P 515274-A

ON-SITE SEWAGE DISPOSAL SYSTEM HOWARD COUNTY HEALTH DEPARTMENT BUREAU OF ENVIRONMENTAL HEALTH

SUBDIVISION: Avery Property LOT NUMBER: 1

ADDRESS: 14371 Frederick Road PROPERTY OWNER: Cornerstone Homes

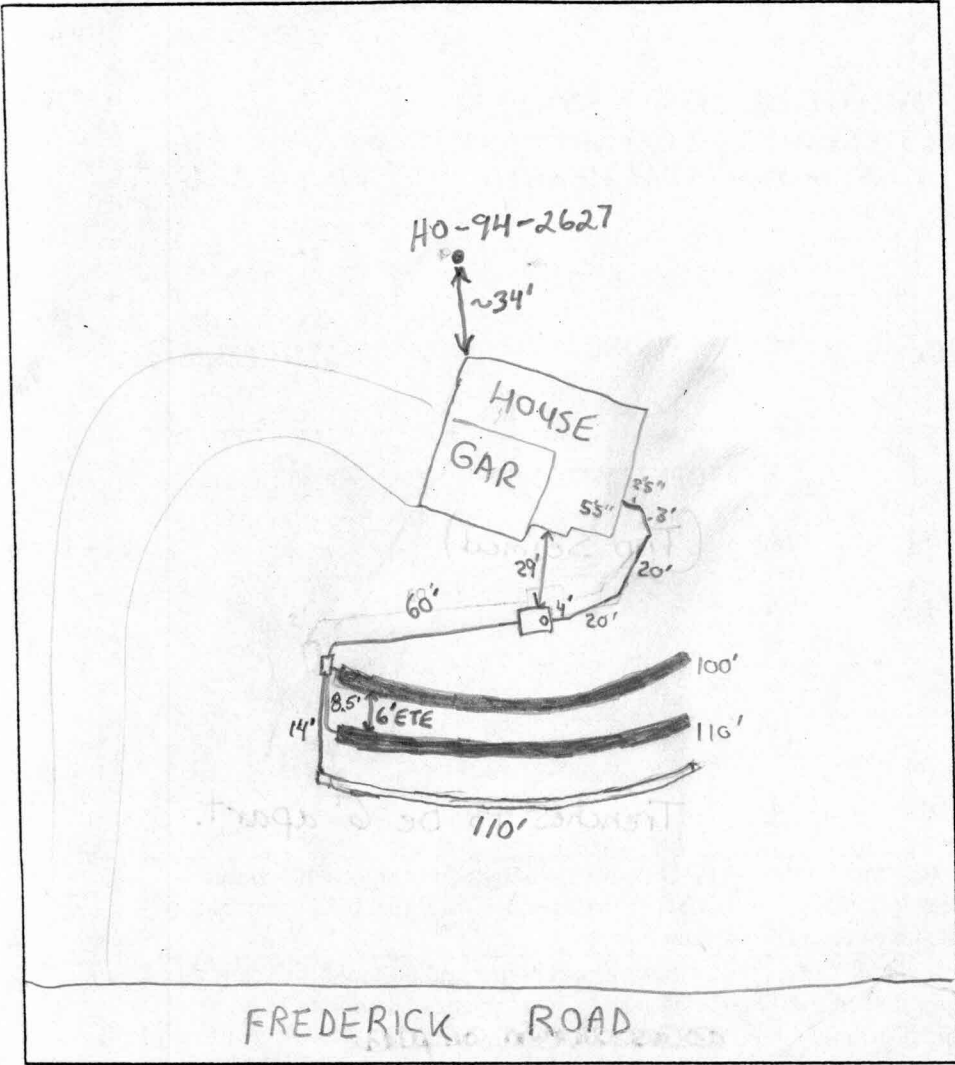
PRE-CONSTRUCTION INSPECTION: 6/8/01 Easement not staked. Nud wall check. (BB)

INSPECTION COMMENTS: 6/19/01- OK TO CONTINUE WORK, OPEN TRENCH INSP. OK, (SRK)

6/13/01- OK TO CONTINUE WORK, PUT MANHOLE ACCESS ON SEPTIC TANK, AND FINISH 3RD TRENCH (SRK)

6/14/01 Everything satisfactory. O.K. to cover. (BB)
